STAFF MEMORANDUM

Subject: **Case SP #2022-03 Amherst Label Realty, LLC, Tax Map 15, Lot 15, 15 Westchester Drive**
Public Hearing for a Major Site Plan to construct a 13,305 square foot building addition, stormwater management design, and related site and landscaping improvements within the Industrial zoning district.

**Re: Amherst Label Expansion (Tax Map 15, Lot 15)
Site Plan Drainage Review**

Response Letter #1

SP-1
 SHEET

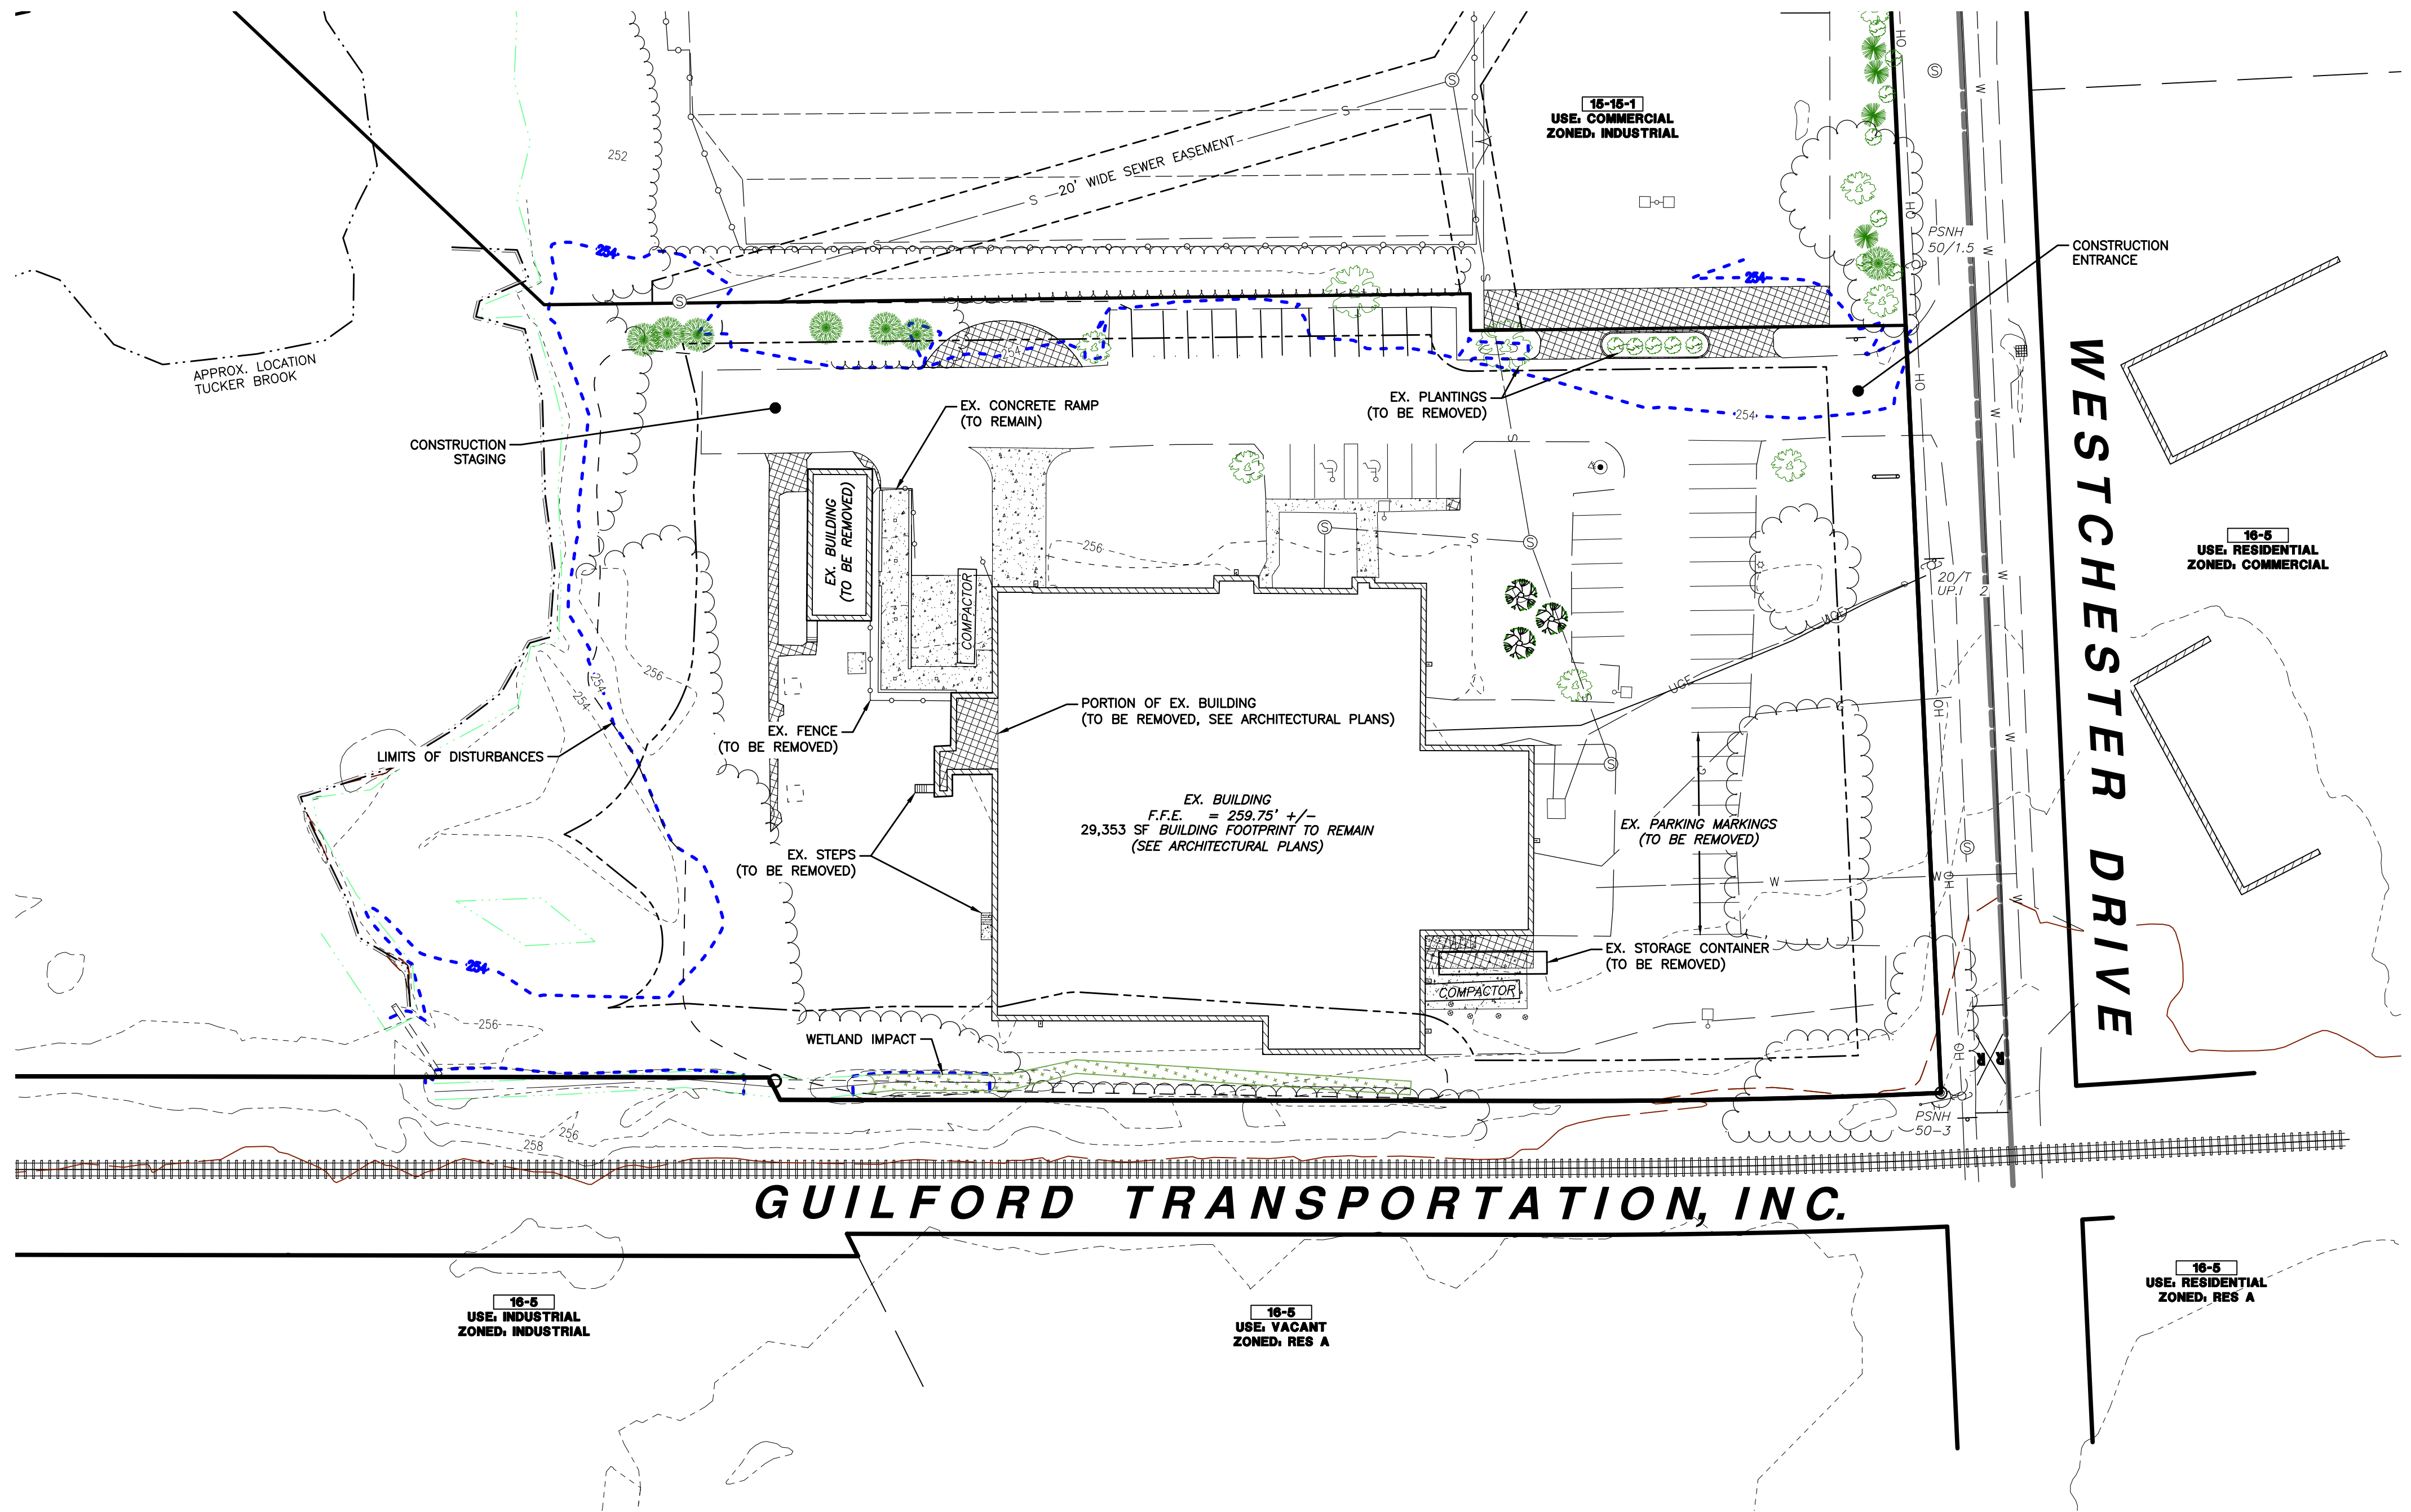
6. *Question – Site Plan, Sheet 3 (SP-1). Please revise the sheet to display the proposed silt fence line and erosion control measures during construction. In addition, please revise the plan to show where the staging area(s) for materials and equipment for the proposed addition will be stored.*

7. *Question – Site Plan, Sheet 3 (SP-1). Demolition Note #1 should be revised to read “Erosion Controls to be installed and inspected by the Town prior to ground disturbance.”*

8. *Question – Site Plan, Sheet 3 (SP-1). Demolition Note #2 should be revised to include the Town of Milford in the notification process prior to ground disturbance.*

Silt fence is shown on the erosion control plan on Sheet 10 (D-3). Note 1 of the Demolition Notes has been revised to state "Erosion control to be installed prior to ground disturbance. See erosion control to be installed prior to ground disturbance. See erosion control plan, sheet D-3." See sheet 3 and 10.

Note 2 of the Demolition Notes has been added to state “Erosion controls to be inspected by the town prior to ground erosion controls to be inspected by the town prior to ground disturbance.” See sheet 3.

Note 2 of the Demolition Notes is now note 3. This note has been revised to include the town in the notification process. Note 3 of the Demolition Notes states “The contractor shall notify the owner, the town, and contact all utility the contractor shall notify the owner, the town, and contact all utility companies for locations of existing utilities in the area 72 hours (minimum) prior to commencing demolition.” See sheet 3.

SP-2
SHEET
FILE: 5073106C.dwg
PROJECT 05073.06
SHEET NO. 4 OF 10

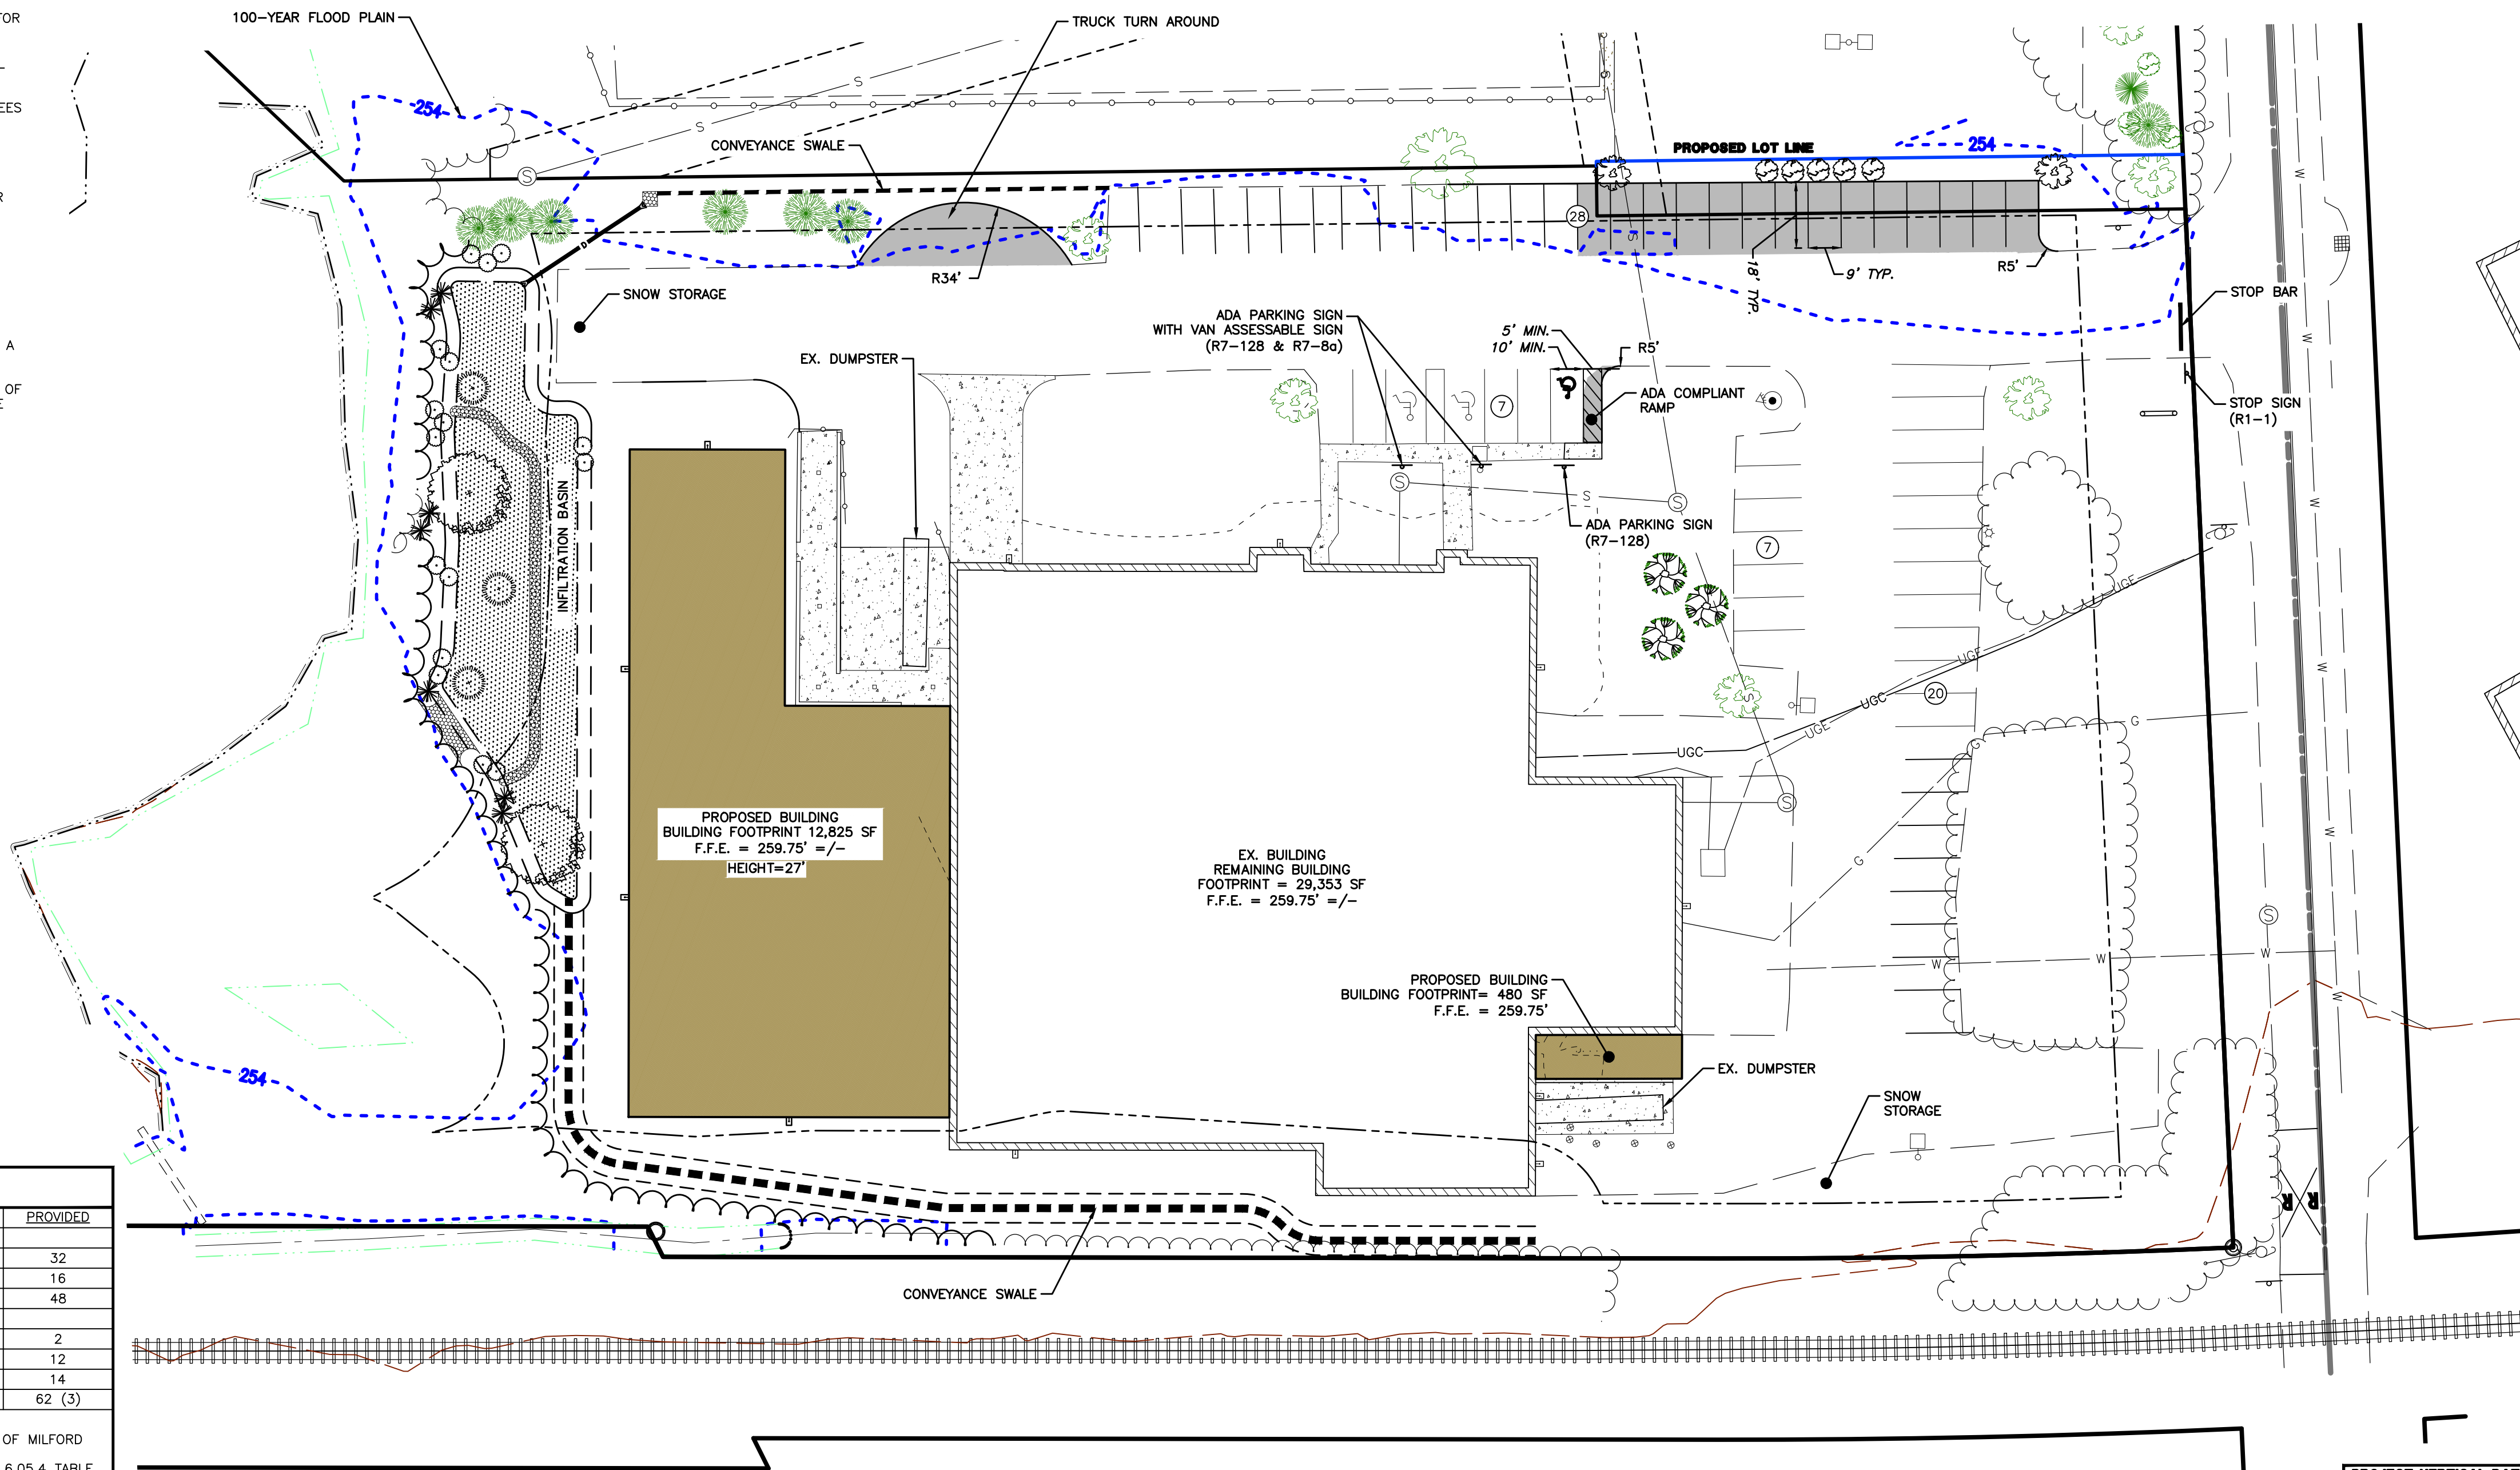
10. *Question – Site Plan, Sheet 4 (SP-2). Please revise Note 4 by removing “with City of” from the sentence.*

11. *Question – Site Plan, Sheet 4 (SP-2). Please revise Note 15 to include a reference to the Milford Development Regulations and Milford Driveway Regulations.*

12. Question – Site Plan, Sheet 4 (SP-2). Please revise the Site Development Regulations table by replacing the minimum lot size of 40,000 to N/A. Pursuant to Section, 5.06.4, in those areas serviced by both municipal sewerage and water systems, no minimum lot size and frontage shall be required for properties in the Industrial Zoning District, other than those requirements that relate to usable open space so long as access to sewer and water is obtained.

13. Question – Site Plan, Sheet 4 (SP-2). Please revise the Site Development Regulations table by including a reference to the Zoning District designation (Industrial).

14. Question – Site Plan, Sheet 4 (SP-2). Please revise Note 3 within the Parking Summary Table to correct the word “Respesten”.

15. Question – Site Plan, Sheet 4 (SP-2). The handicapped parking space being added should be modified to be 10’ wide by 20’ long.

16. Question – Site Plan, Sheet 4 (SP-2). The parking spaces shown along the eastern portion of the property appear to not meet the minimum dimensions for parking spaces. Please confirm if all parking spaces shown and/or proposed meet the current 9’ x 18’ parking space dimensions.

18. Question – Site Plan, Sheet 4 (SP-2). The plan shows a truck turnaround area in the northwest portion of the developed area. Please explain the maximum size vehicle this will serve and provide the turning movements templates.

Note 4 of the General Development Notes has been revised to remove “with city of”. Note 4 of the General Development Notes states “All construction to be in accordance with the town of Milford zoning all construction to be in accordance with the town of Milford Zoning Ordinances and Site Regulations.” See sheet 4.

Note 15 of the General Development Notes has been revised to state “Where applicable; water, sewer, roads (including parking lots), and where applicable; water, sewer, roads (including parking lots), and drainage work shall be constructed in accordance with the town of Milford water department and public works department standards, development regulations, ad driveway regulations.” See sheet 4.

Site Development Regulations table on sheet 4 has been revised to the required lot size as N/A. See sheet 4.

Note 1 of the Site Development Regulations table state “Site development regulations in accordance with the Town of Milford Zoning Ordinance – Industrial district.” See sheet 4.

Note 3 of the Parking Summary table has been revised to correct the spelling. It now states ““(#)” represents the number of ADA spaces within the total.” See sheet 4.

The proposed handicap parking space has been revised to be 10’ x 20’. See sheet 4.

The parking in question is existing parking the parking length is currently substandard. The parking marking are proposed to be restrained to be 18’ long. The existing parking along the remaining site has been verified to comply with Milford’s standards.
